ARCHITECTURAL DESIGN AND ACCESS STATEMENT ADDENDUM

Proposed New Dwelling at Town-o'-rule

SADLER BROWN ARCHITECTURE

This document supplements a planning application submission for a new dwelling at Town-o'-rule near Bonchester Bridge, dated June 2018 (ref 18/01194/FUL). This document should be read in conjunction with the Architectural Design and Access Statement, the formal drawings and accompanying reports submitted as part of the full planning application.

2018 Application Scheme (Above) and 2019 Amended Scheme House Plans (Below) (Not to Scale)

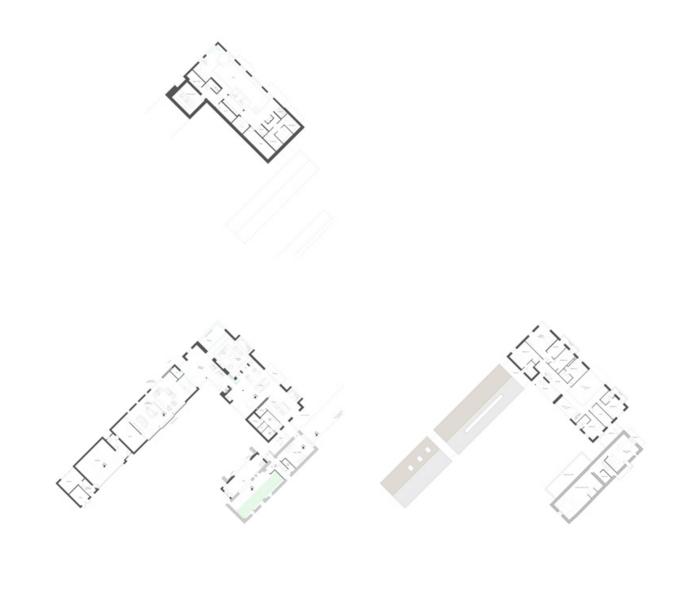
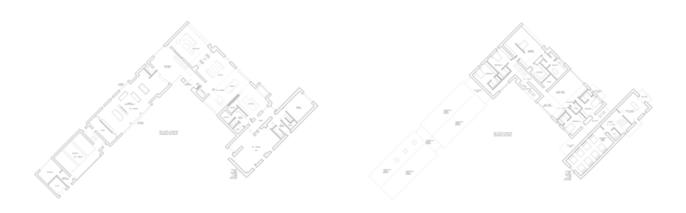
From the dialogue it was agreed, from the perspective of the Planning Authority, that the 'horse-shoe' layout of the proposals, utilising the existing stone building with a new 'mirrored' building facing and a central 'main' house section, was a suitable response to the site and farmstead language. It was also agreed that the language and massing employed in the design of the west elevation 'wing' was deemed to be a suitable response to the site. The Planning Authority however, expressed concerns that, without being addressed, would result in recommendation for refusal. A summary of the concerns raised, taken from the Design Teams notes in February 2019, are as follows:

- Concerns over the massing and scale of the project which would prevent them from supporting the scheme, particularly the central section of the horseshoe and its north elevation.
- Concerns were discussed over the north elevation and it was suggested to break up the horizontally of the elevation. Increasing the vertical elements within the elevation would help to break up the horizontally, and potentially this could be developed further via the introduction of a taller, vertically proportioned element. Breaking up or creating a step within the ridge line could also help to reduce the massing and horizontal language.
- It was felt that there should be a more domestic feeling to the main house block, particularly the north elevation, as it is felt that the current approach is more commercial in its language.

The Planning Authority welcomed a submission of alternate massing and elevations options (particularly relating to the north elevation) for review with the aim of working with the Design Team to alleviate the concerns. The Design Team subsequently developed a series of 3D massing options that were tabled to the Planning Authority in August 2019.

Amended Elevations (Not to Scale)

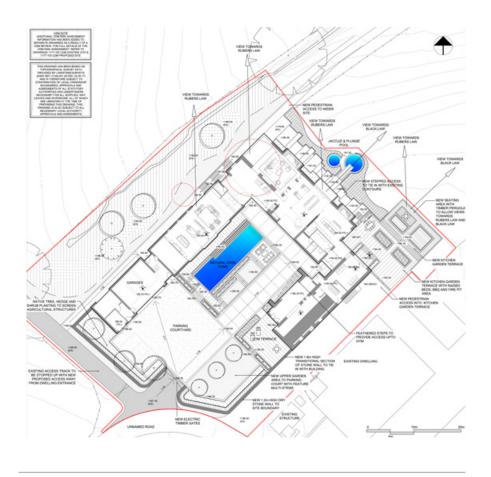
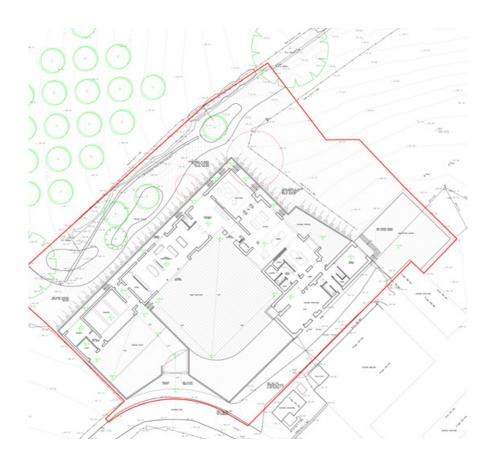
The Planning Authority reviewed the options and supplied a formal response in July 2019: Despite the efforts of the design team to reduce the perceived scale without compromising the accommodation requirements, the Authority expressed that the central main house was still 'too large and out-of-character with the site of the former farmyard'. As a result the Authority would anticipate that each option would be recommended for refusal.

In addition, the Authority supplied a mark-up of the August 2018 planning application south and east elevations to indicate the scale of the central main house form that they would accept as in-keeping with a 'traditional rural farm building' (opposite), showing significantly reduced heights of the roof ridge line, eaves positions and footprint.

The team, alongside the client, decided that pursuing the development of Option 04 would be the preferred route to amend the design and re-submit to the Planning Authority. A summary of the design changes from the development of Option 04 are as follows:

- The northeastern edge of the proposed central main house section is moved further southwest away from the existing steep fall in topography to reduce the perceived verticality to views from the north.

- The central main house form is shortened along the northwest-southeast axis with accommodation relocated in the west wing, which is extended northeast. The west wing is subsequently split into three forms with the new third form accommodating two levels under a newly proposed metal-finish standing seam roof (as opposed to timber).

- The central main house roof line is split and stepped to further break-up and reduce the perceived horizontal aspect.
- The lower subterranean level is omitted along with the proposed exercise pool and sauna that were accommodated in this level.

- The new position of the main house rests in front of the existing stone building to be renovated, located approximately in the centre of its elevation and is proposed to be separated by a larger lobby structure.

- Balconies off the ground floor reception room and dining room are omitted.
- The gables of the central main house are proposed in stone rising to form two chimney structures either side to give a greater domestic feel, while in keeping with the materiality of the existing adjacent stone buildings.

2018 Application Scheme (Above) and 2019 Amended Scheme (Below) Site Plans (Not to Scale)

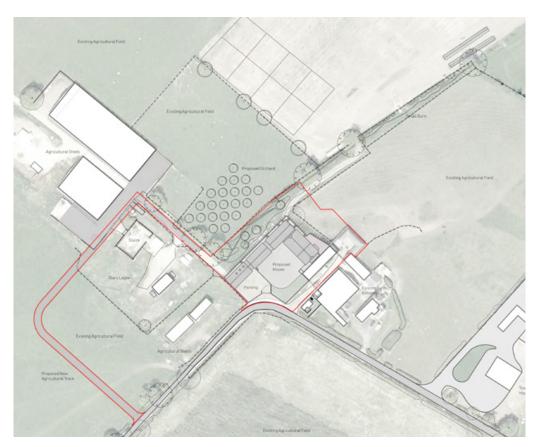
The proposed domestic curtilage of the amended design varies in position to the previous 2018 proposals as a result of moving the northeastern edge of the proposed central main house section further southwest. In principle the area of curtilage does not vary.

The landscaping proposals in the amended design have been pared-down in comparison with the 2018 scheme, with the intention of being more conservative in creating the sense of a traditional farm steading. Changes include:

- All external water features have been removed, including the natural swimming pond, jacuzzi and plunge pool.
- The courtyard is reduced to a single datum of natural stone paving replacing the stepped terraced spaces.
 Structural planting offer visual interest to the southernmost edge of the courtyard.
- High quality lawn adjoins the building and associated stepped path low natural stone retaining wall edge to the north, blending outward into the native rough grass context.
- The kitchen garden inside the existing stone wall structure is maximised and domestic features such as the pergola, timber decking and ornamental planting are removed.
- A terrace of timber decking with views north adjoins the internal dinning and kitchen spaces along the north edge.
